**PLANNING COMMISSION AGENDA  
FEBRUARY 18, 2021 – 6:30 P.M.**

**Planned Unit Development Site Plan—Lots 2 & 3  
Gary & Debbie Pink No. 3—TNT Holdings, LLC**

**CITY OF LA VISTA  
PLANNING DIVISION  
RECOMMENDATION REPORT**

RE: Planned Unit Development – Initial Review  
TNT Holdings

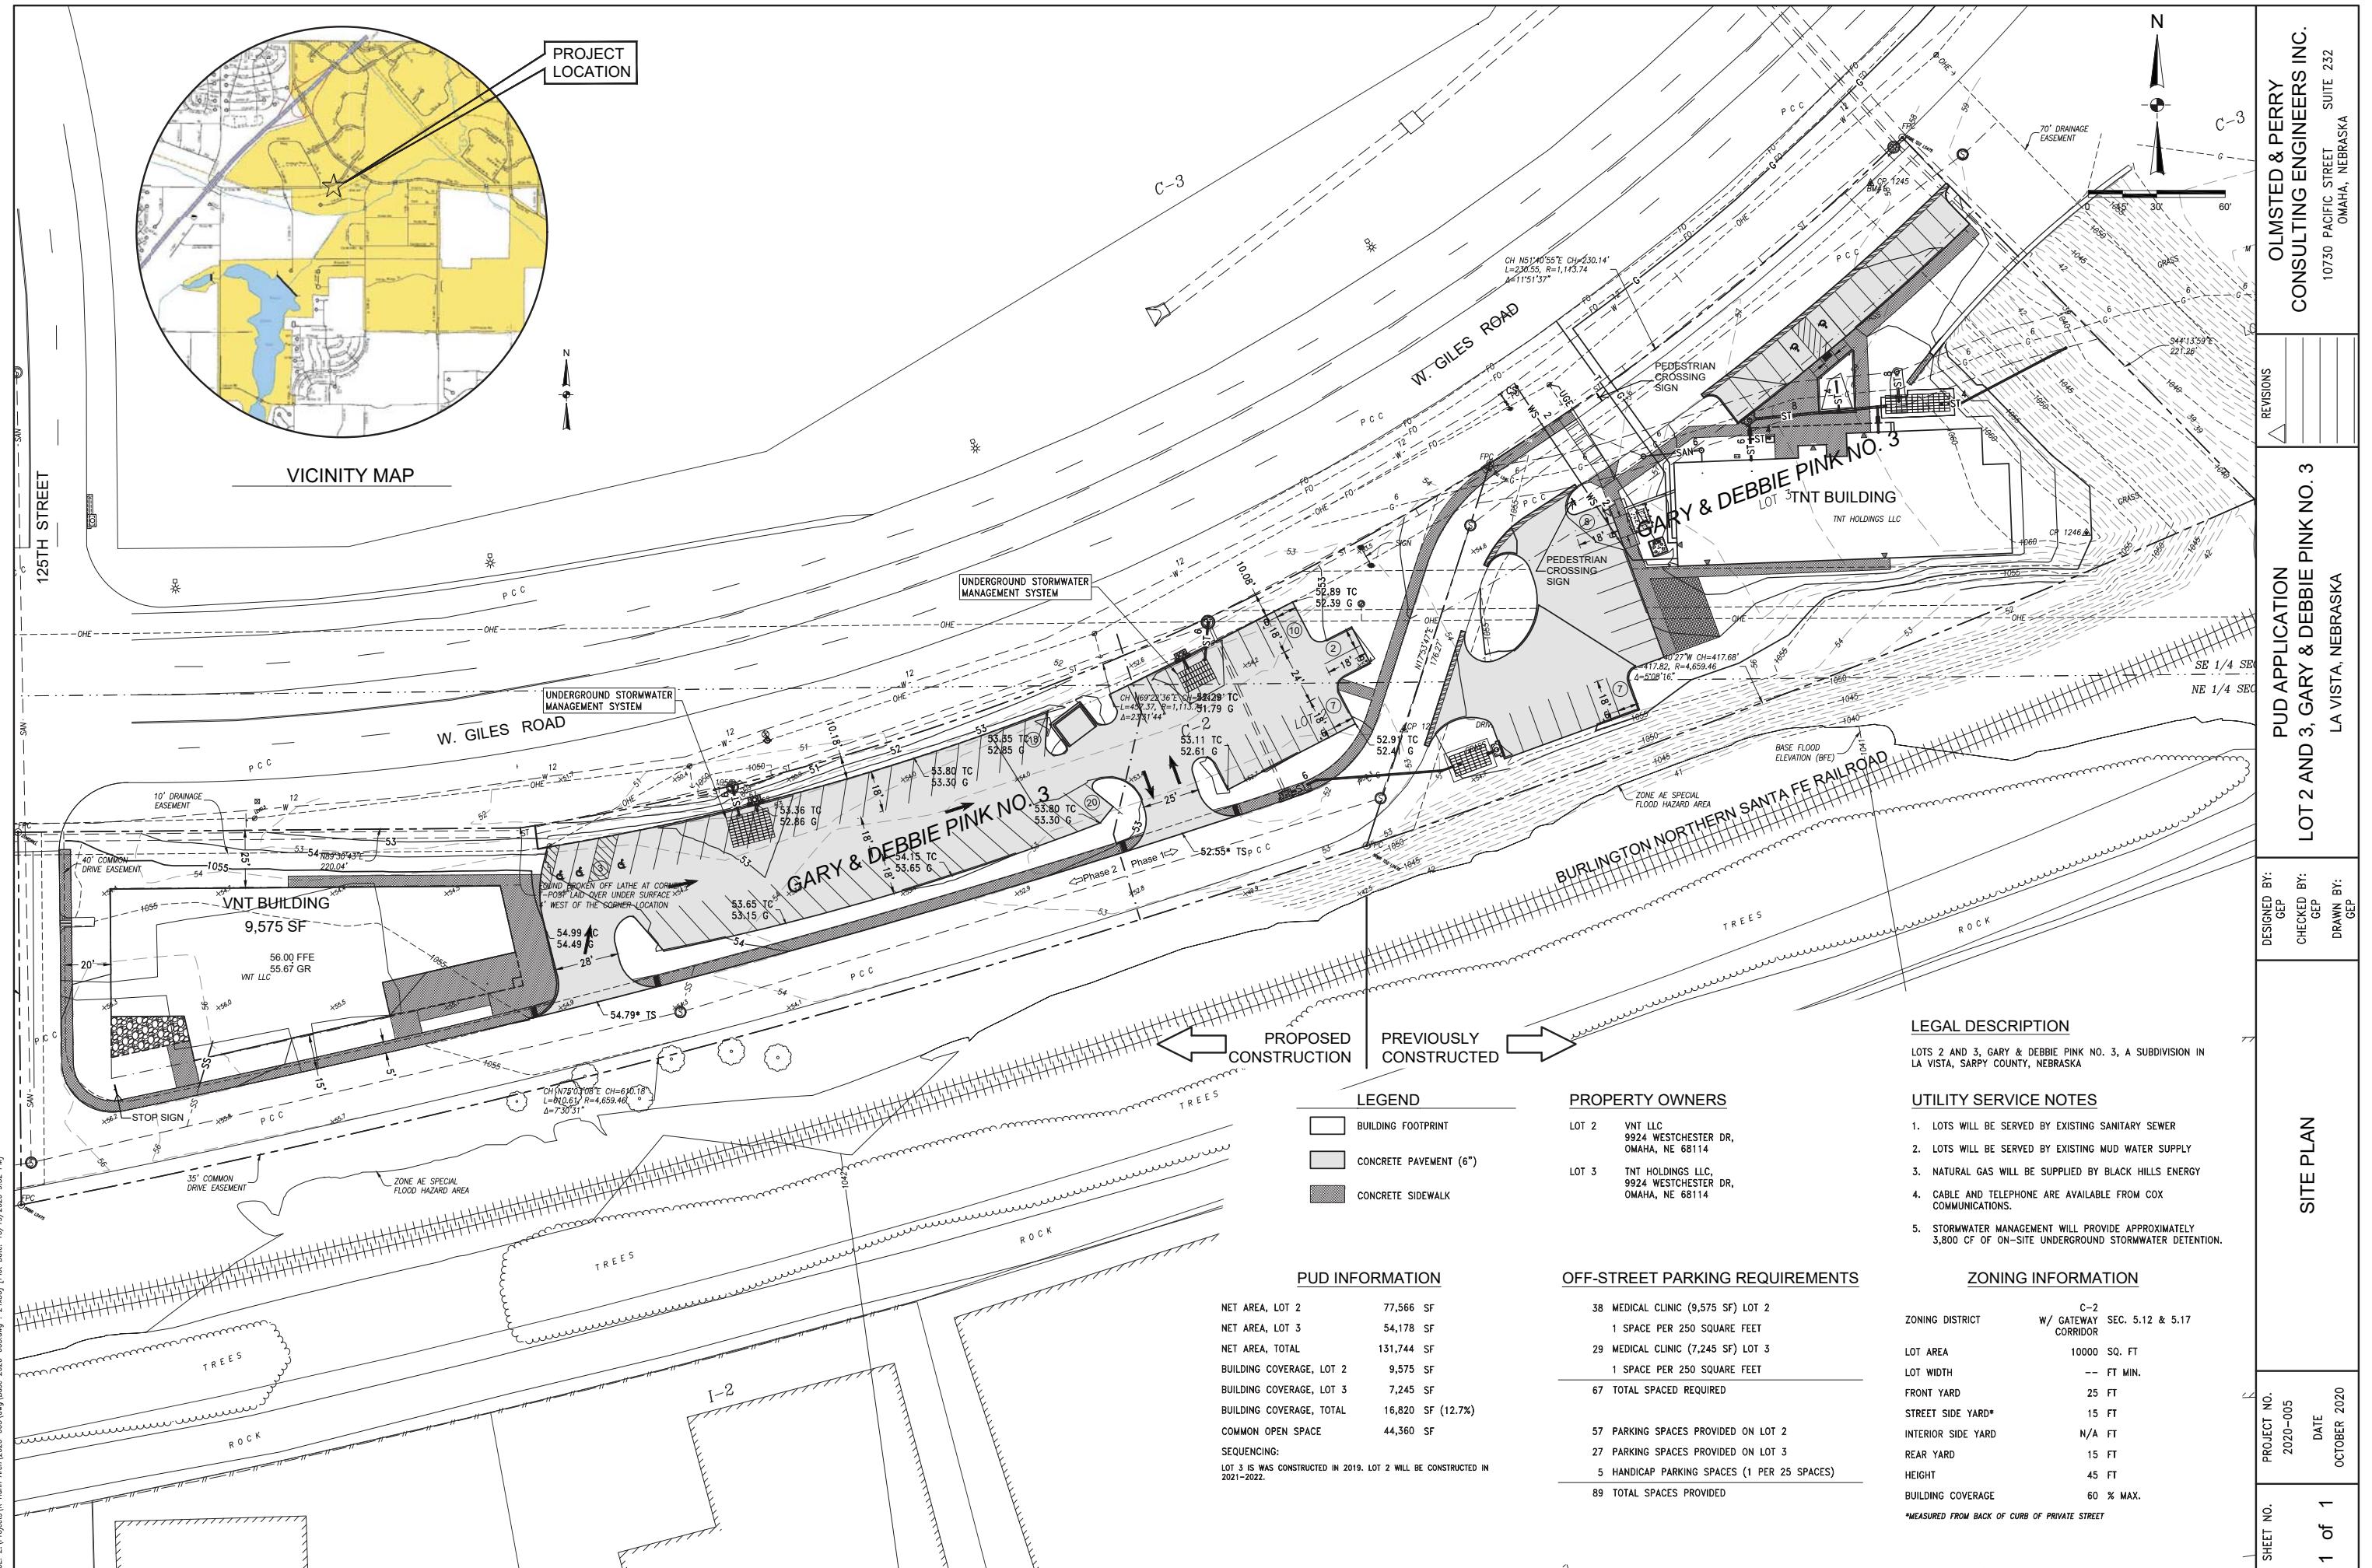
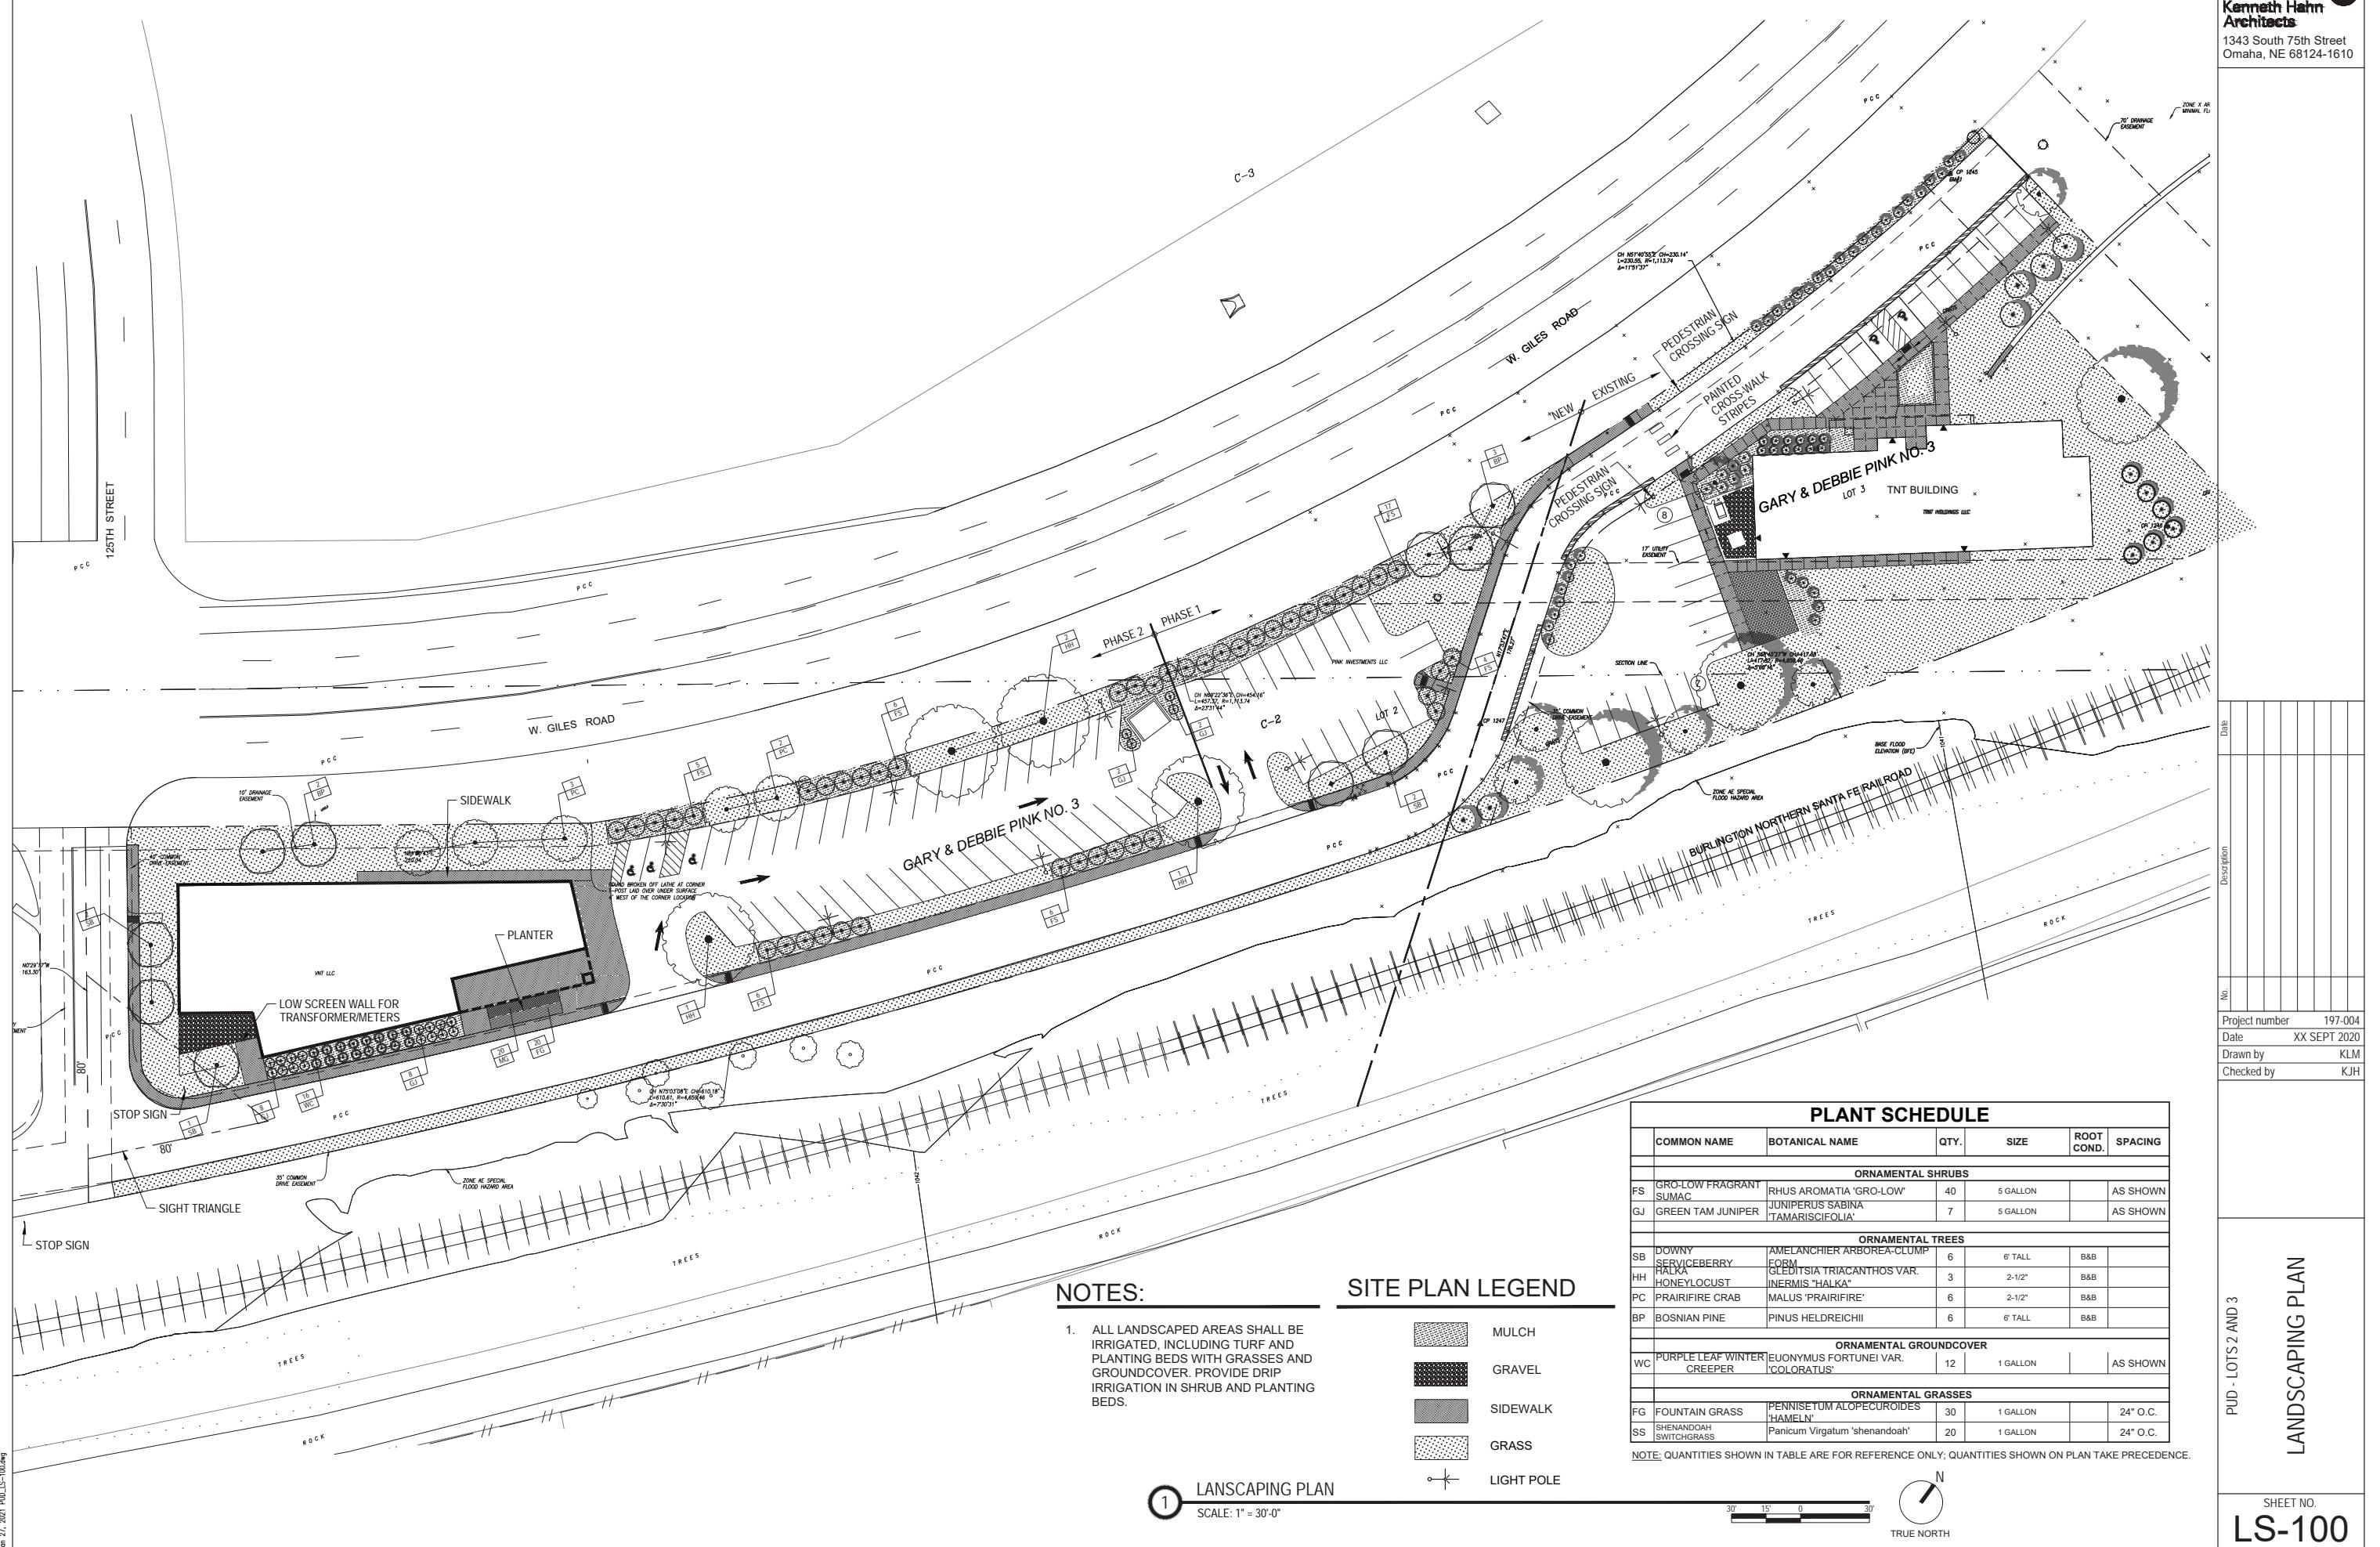
1. LS-100 Landscaping Plan:
  - a. See section 7.17.03.07 of La Vista Zoning Ordinance. All commercial office and industrial developments...shall provide perimeter landscaping to include a min. (1) tree for each forty (40) lineal feet of street frontage. Please verify and indicate on the drawing that the plan complies with this ordinance.

- b. See section 7.17.04.01 Screening Requirement of La Vista Zoning Ordinance. Parking areas abutting a public right-of-way are required to be screened from grade to a height of three feet. The trees and bushes indicated as a buffer between the public right-of-way and the parking are deciduous and will likely not have canopy to provide screening below 3 foot. Solid fences, walls, berms, hedges, shrubs, or evergreen trees are allowed by the ordinance. Please revise to show compliance with the ordinance.

- c. See Section 4, III, F, of the La Vista Gateway Corridor District Design Guideline. This guideline also requires natural undulating landscape forms. Avoid consistent straight-line plantings.

- d. See section 4, III, K. Storm water management is to be integrated into the site and landscaping. Please show how this will be integrated in your plan.
